### **PLAN COMMISSION MEETING**

Thursday – March 31, 2016 – 7:00 pm

**STAFF REVIEW COMMENTS**  
**Plan Commission Meeting – March 31, 2016**

JACKSON-PIGGLY WIGGLY  
 GRADING AND EROSION CONTROL PLAN  
 DATED: MARCH 4, 2016

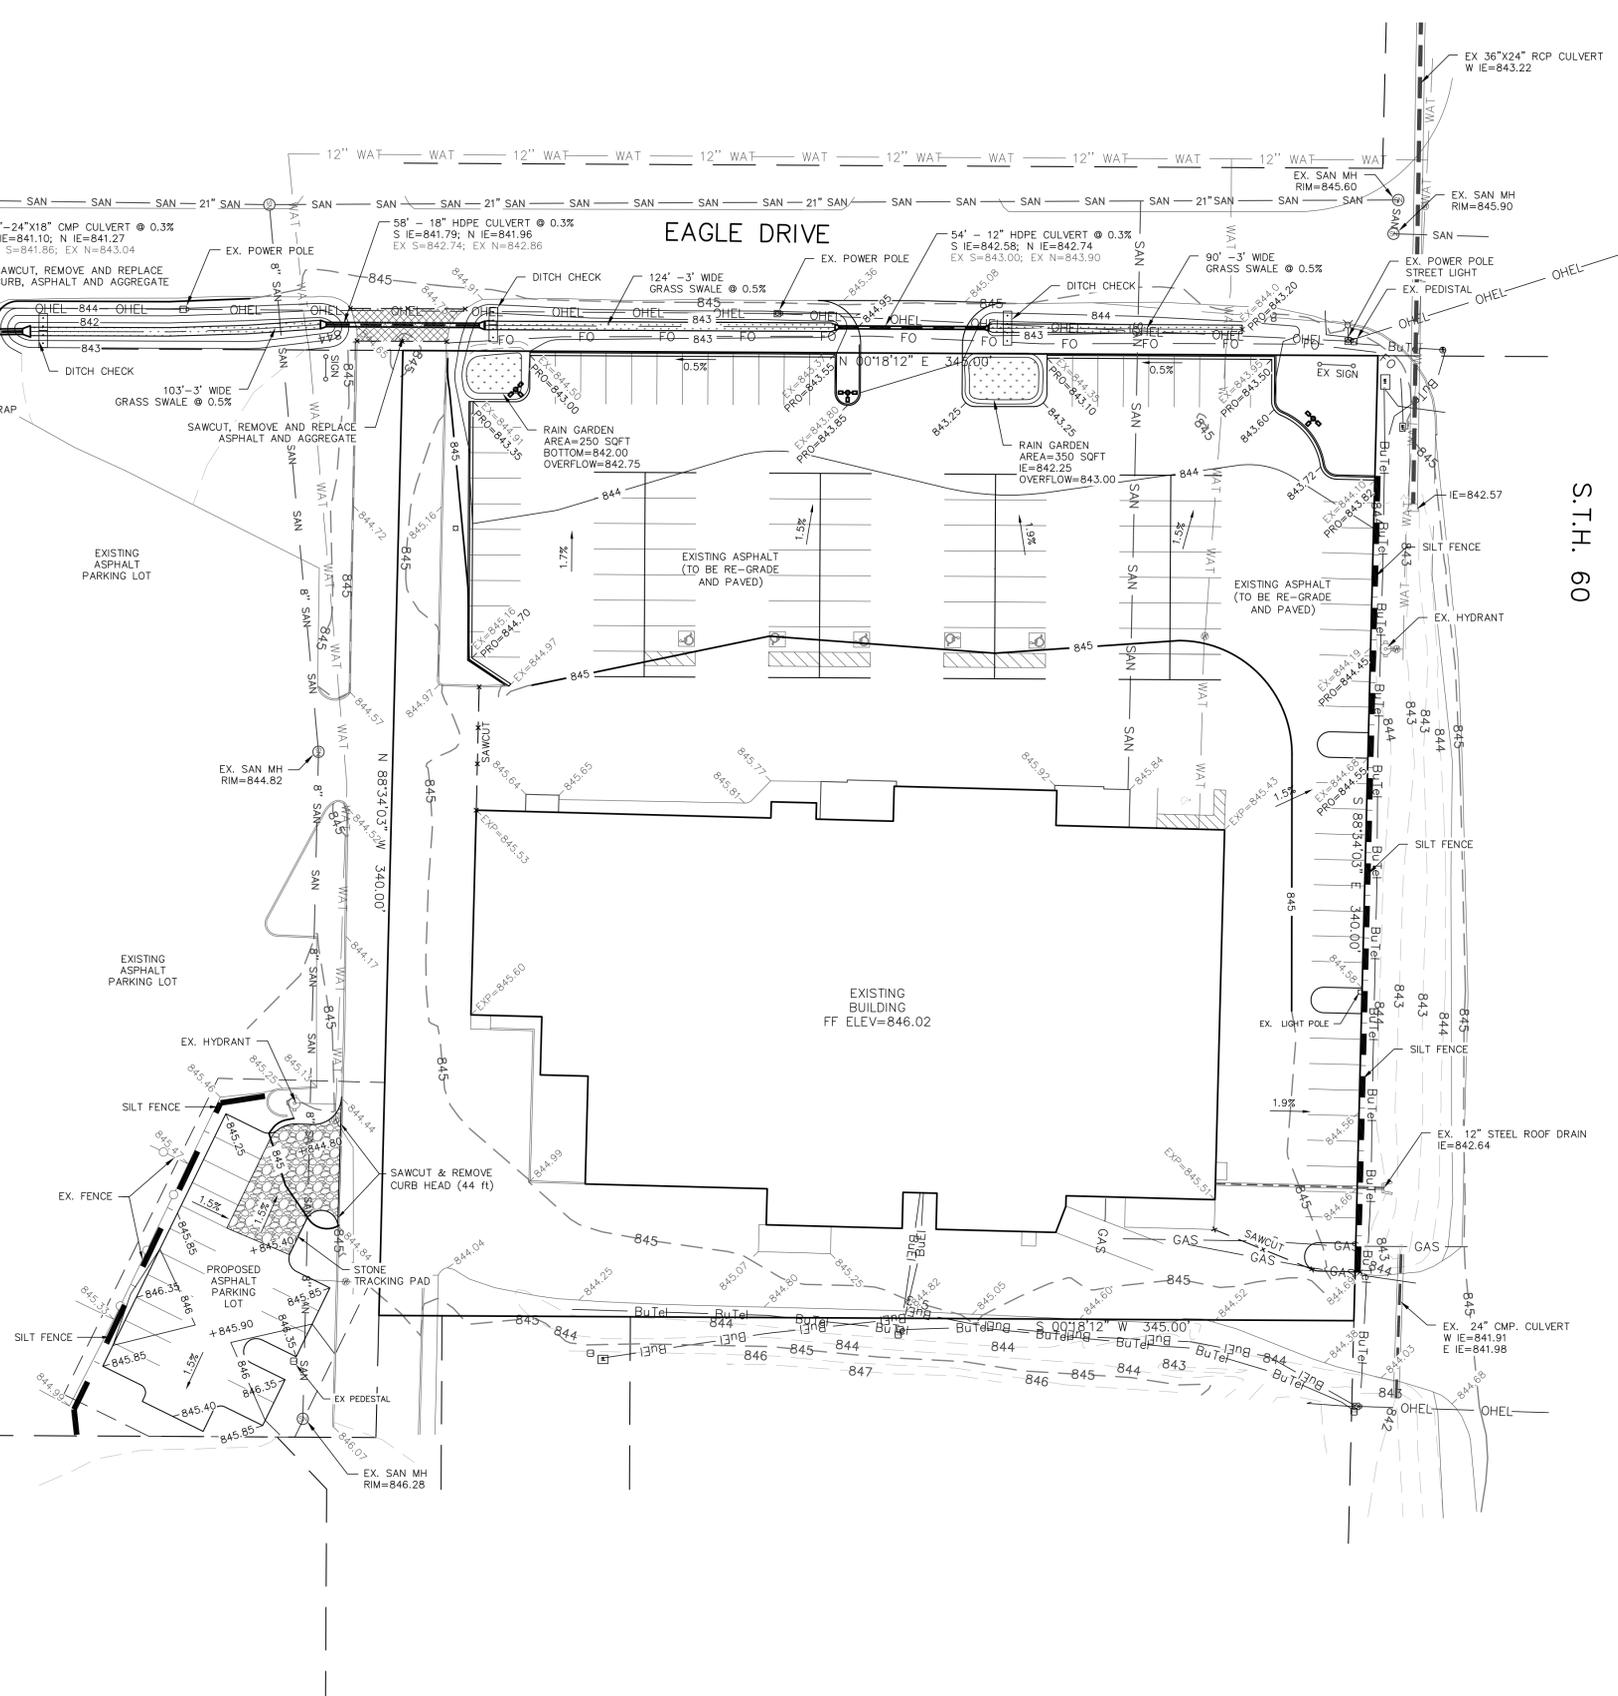
- The parking lot for the grocery store has been in need of improvement for years. The proposal is to remove and re-grade the asphalt for allowing storm water to accumulate in rain gardens and then discharge into the ditch line of Eagle Drive. The proposal is requiring the re-grading of the Right of Way of Eagle Drive. The site drainage is challenged by the minimum grade difference between the site and the creek. Future reconstruction of Eagle Drive will determine the relationship of pedestrian access to the required drainage.
- The proposed plan has been reviewed per the proposed Storm Water Management Plan and has met the requirements of the management plan. The property shall submit to the Village of Jackson for approval, a maintenance plan for the rain gardens and the Eagle Drive drainage ditch.

- This project will allow for additional parking, a more usable lot, as well as provide for better drainage in an area that is challenged by minimal grade variation from the site to the creek.
